From: Roland Benke
Sent: Monday, July 11, 2005 4:48 PM
To: Timothy McCartin; Donald Hooper; Christopher Grossman; Richard Codell
Cc: Andy Campbell; James Winterle
Subject: RE: ashremob calculations
Attachments: InitialDepOnly_r256.xls; parameter_values.txt

Preliminary ASHREMOB Results: Initial Deposit Contribution Only,
 Fluvial and Eolian Weighting Factors Set to Zero, 512 Realizations,
 Raw rgssa.tpa Output Displayed (Results Have Not Been
 Probability Weighted)

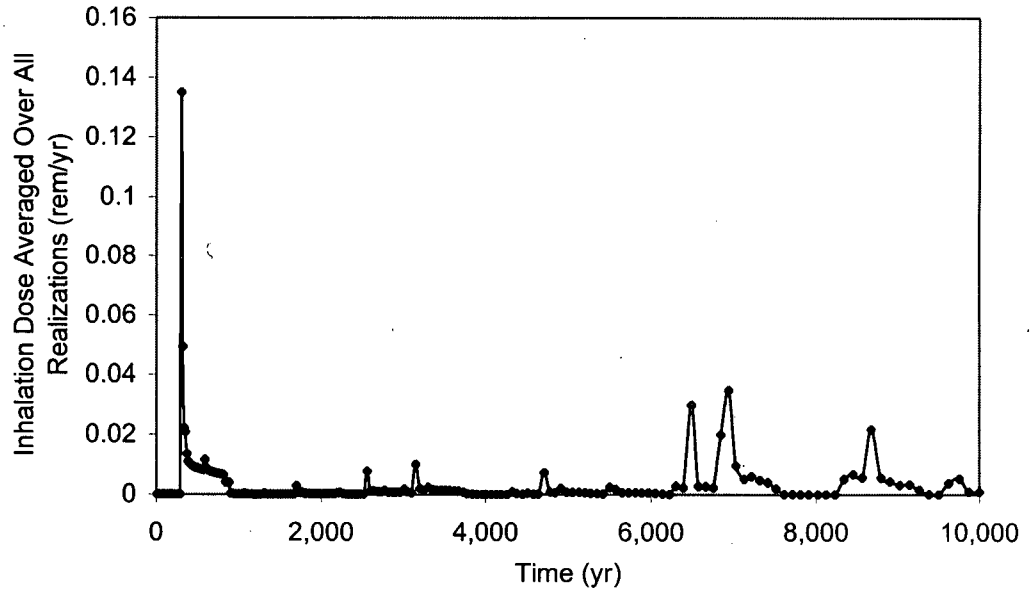
In order to highlight the contribution from the initial deposit, I set the weighting factors for fluvial and eolian remobilization to zero. Several short-duration spikes from individual realizations are noticeable in the curve for inhalation dose averaged over all realizations (see plot in the attached spreadsheet). Please note that the plotted results are raw data from the rgssa.tpa output file and have not been probability weighted. The second attachment lists changes made to the TPA input parameter values from their default settings.

It looks good, but I am concerned that these calculations with ashremob don't pick up the spiky part of the dose caused by the direct deposition at the RMEI by airborne transport. If you run same case without ashremob, it uses the old ashplume model with wind directed toward the RMEI, and leads to relatively large, but short-duration spikes. For that case we need to use the convolution procedure, but not apparently with the ashremob calculations since they are spread out in time. My question is "does the new procedure properly take into account the part of the dose due to the direct deposition of airborne ash at the RMEI?"
